ACF12-02-V1.1

Halow WIFI

CHANGE LIST

Halow WIFI

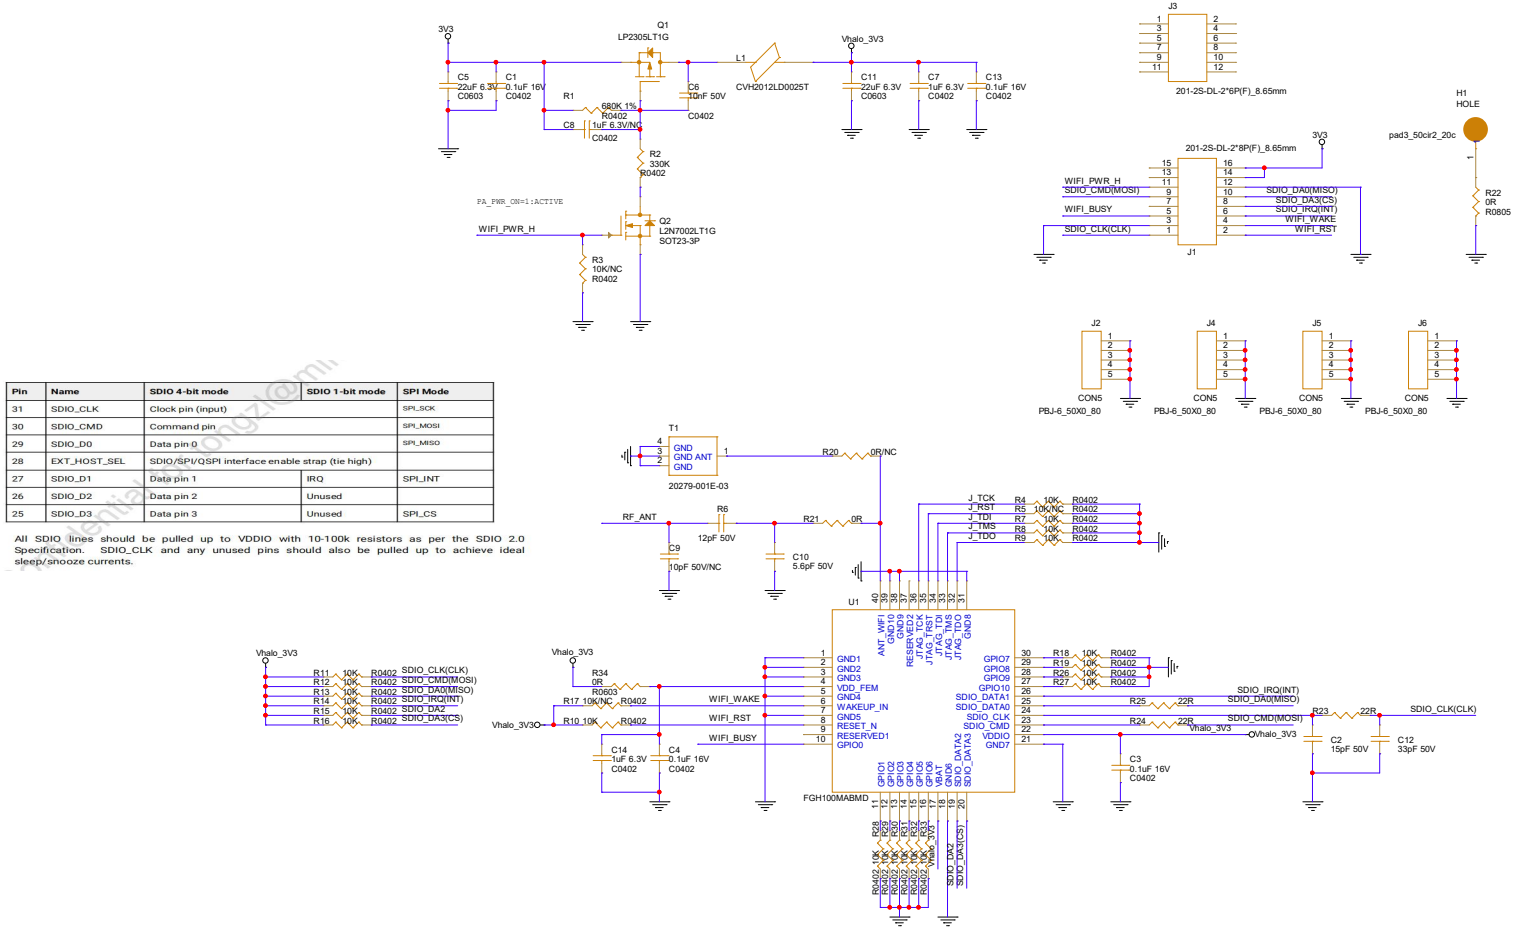
REV. CODE	DATE	Description
V1_0	2024/12/11	New Design
V1_1	2025/04/11	1. Increase the terminal resistance for SPI communication, and increase the RC loop for CLK 2. The GPIOs of the halow module are connected to 10K to the ground to avoid floating, which will cause variable power loss. 3. Supplier feedback that R5 will not be welded
